STAFF DESIGN COMMENT

DEVELOPMENT PERMIT APPLICATION NO. DP001200 – 155 FRY STREET

SHEET TITLE: SITE PLAN

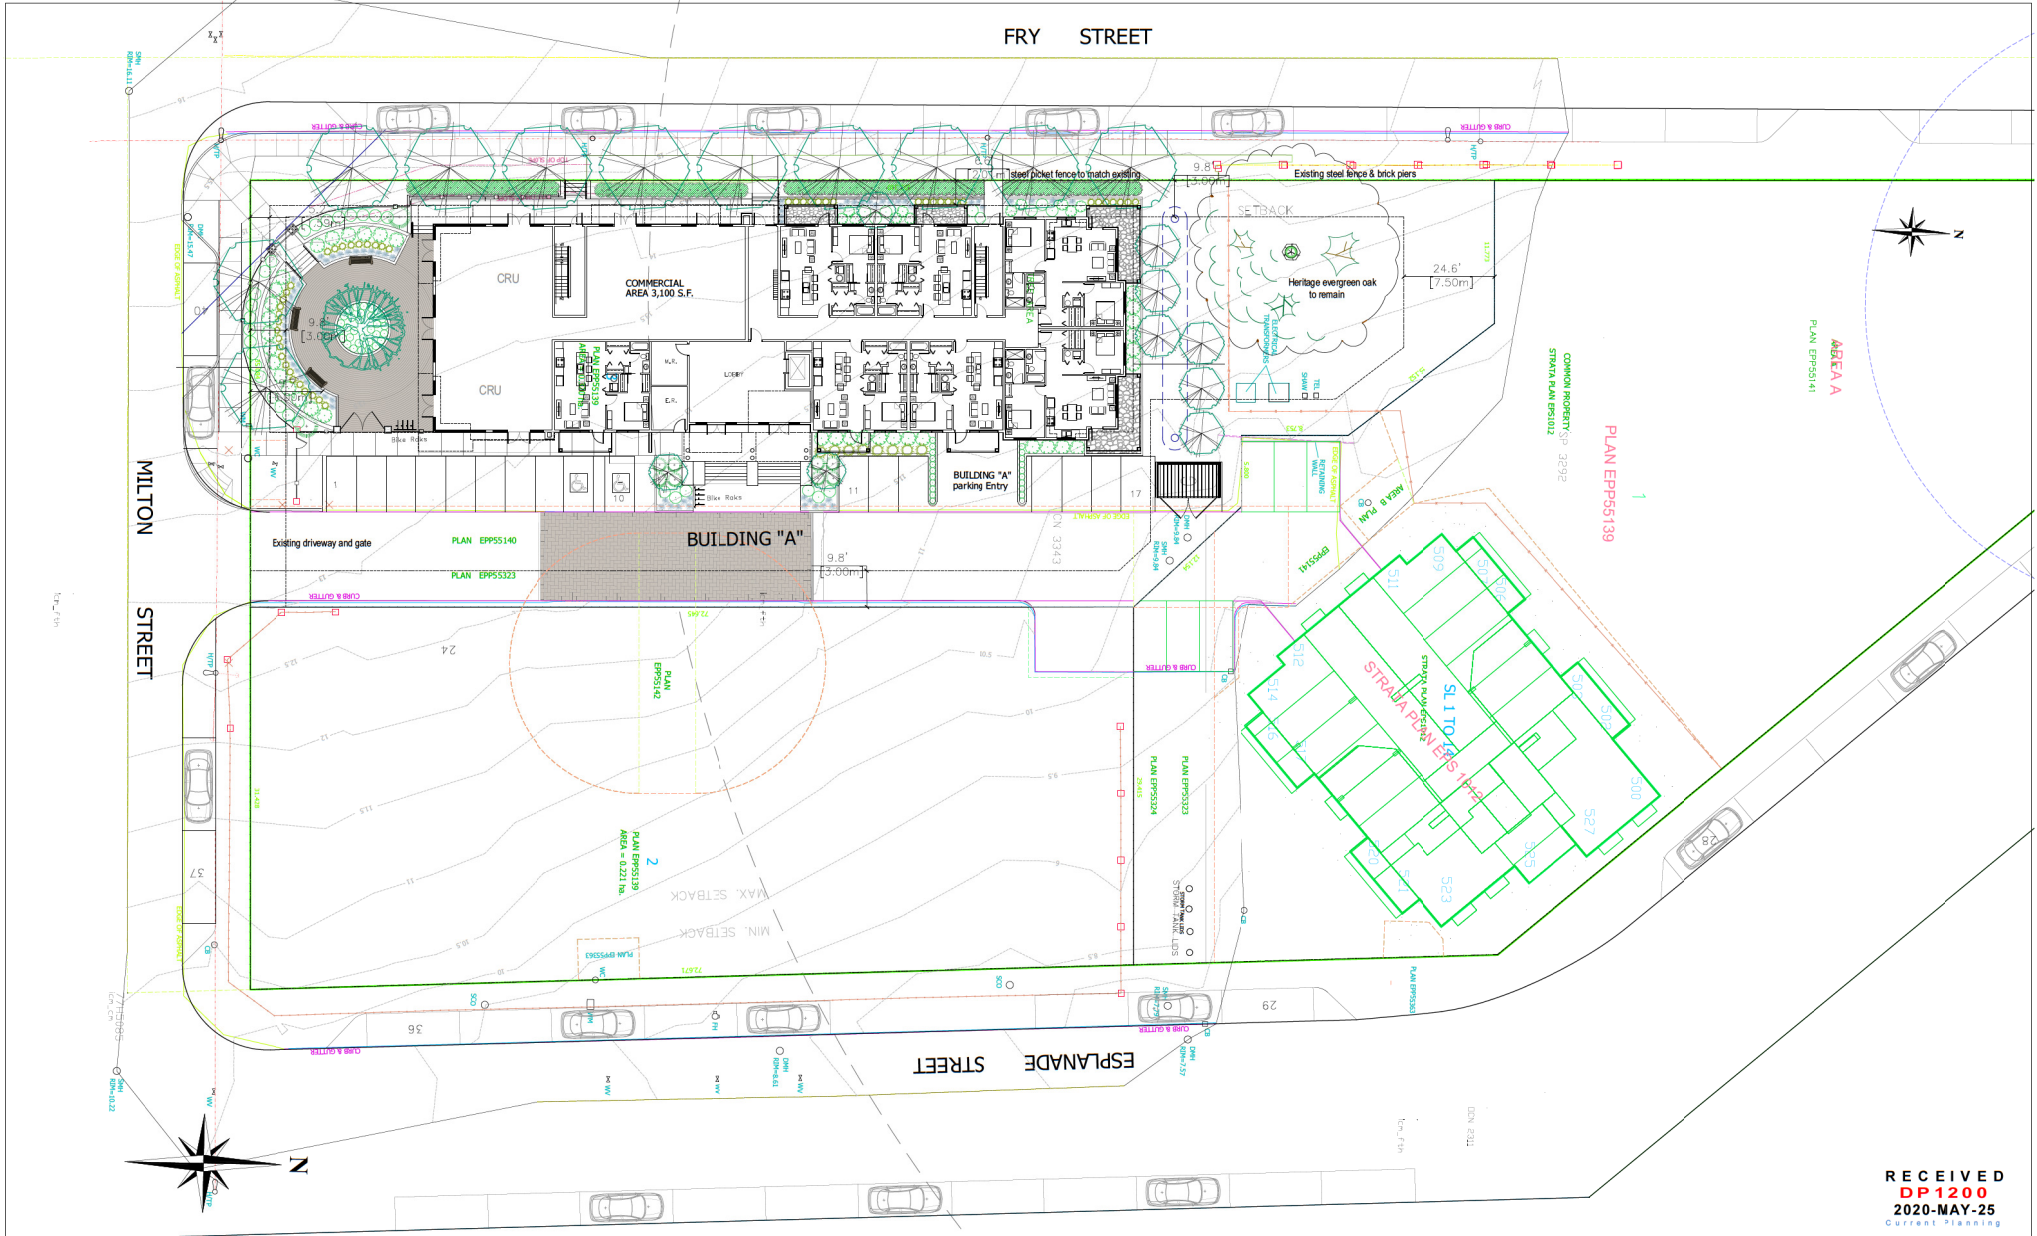
- Explore the opportunity to provide direct pedestrian connections between the ground-level units and Fry Street.
- Ensure that the public plaza is accessible without gates or stairs to impede access for those with mobility limitations.

Public Gateway - Art Concept 1:20

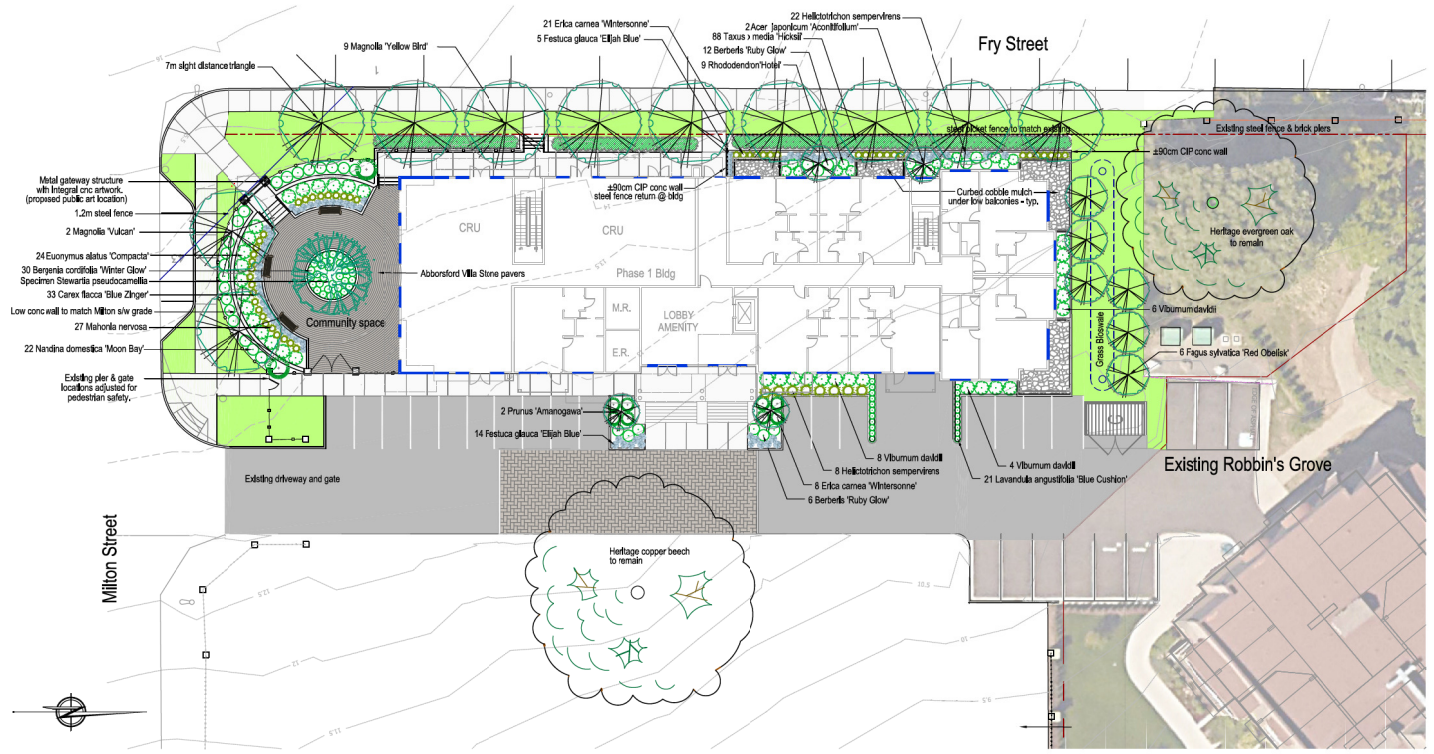
- Provide more rain-garden appropriate vegetation in place of grass for the bioswale on the north side of the building.
- Provide a landscape buffer to surround the refuse receptacle enclosure as per the minimum standard as outlined in Part 17 of the Zoning Bylaw.
